Scarlet Knitwears Ltd. (Extension)

Plot # B 160-163, BSCIC I/E, Fatullah

10 January 2024

1. Building Information

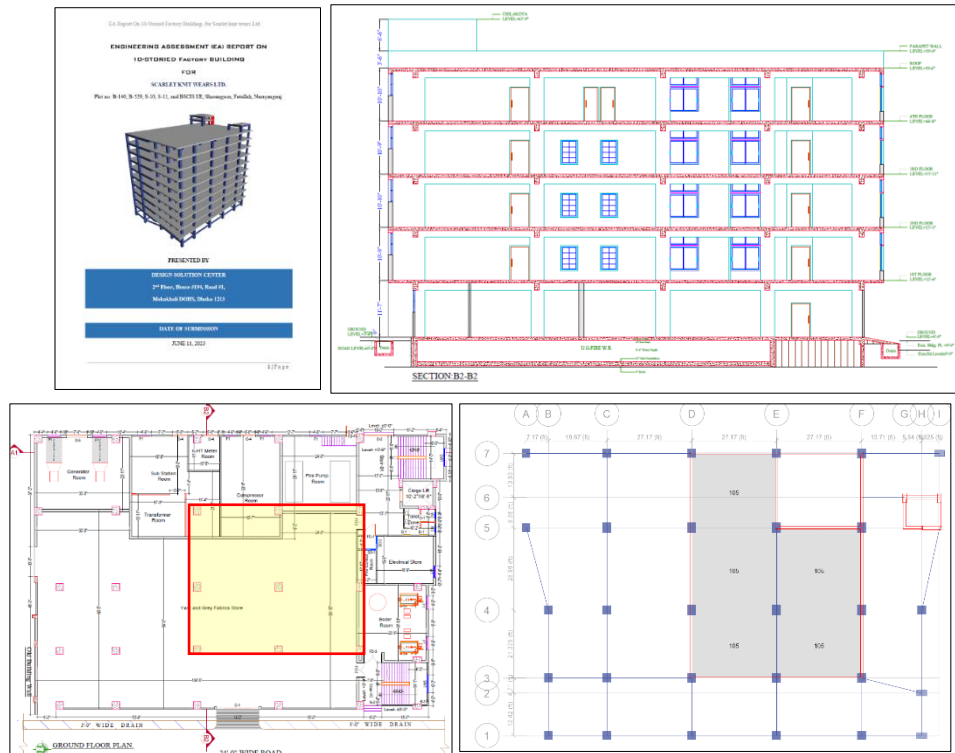
Observation-1: Design documents need to be submitted to RSC for detail review against lateral loadings. (Building-2)

The floor loading has been considered 5kPa in FEA model instead of 6kPa at ground floor (marked location) for yarn and grey fabric store which is suspended slab over the underground water reservoir.

Concrete strength in EA report and FEA model

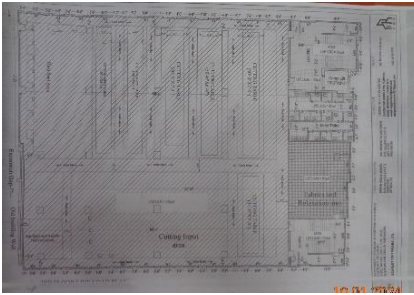
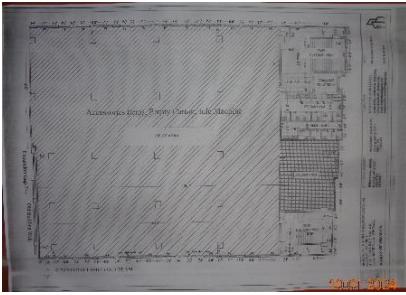
Concrete strength in general note

Description: In general note of the drawing, design concrete strength has been considered 4000psi for the column, foundation, and grade-beam and 3500psi have been considered for the slab & beam. But in the EA report and FEA model 3500psi have been considered for all the structural members. During inspection, Total 35 numbers of concrete core test reports were available where 18 nos from Columns, 8 nos from beam and 9 nos from slab. The building engineer is required to determine the equivalent strength and confirm the design strength is achieved by the core test. Revise the design documents based on in-situ material strength and lateral loadings.

Posted load plan 5kPa at 3rd and 4th floor

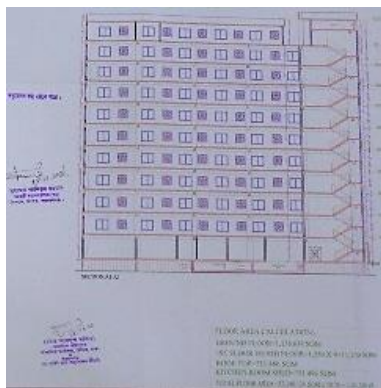
6kPa required for storage

Storage found on the 3rd and 4th floor

Description: During the inspection, storage was found on the 3rd and 4th floor. But in architectural drawing, sewing sections have been shown for the 3rd and 4th floor as well as loading has been considered 5kPa. As per BNBC-2006, 6kPa live load needs to be considered for the storage area. The building engineer is required to update the floor load plan for storage areas, revise the Engineering Assessment (EA) report and submit to the RSC for further review.
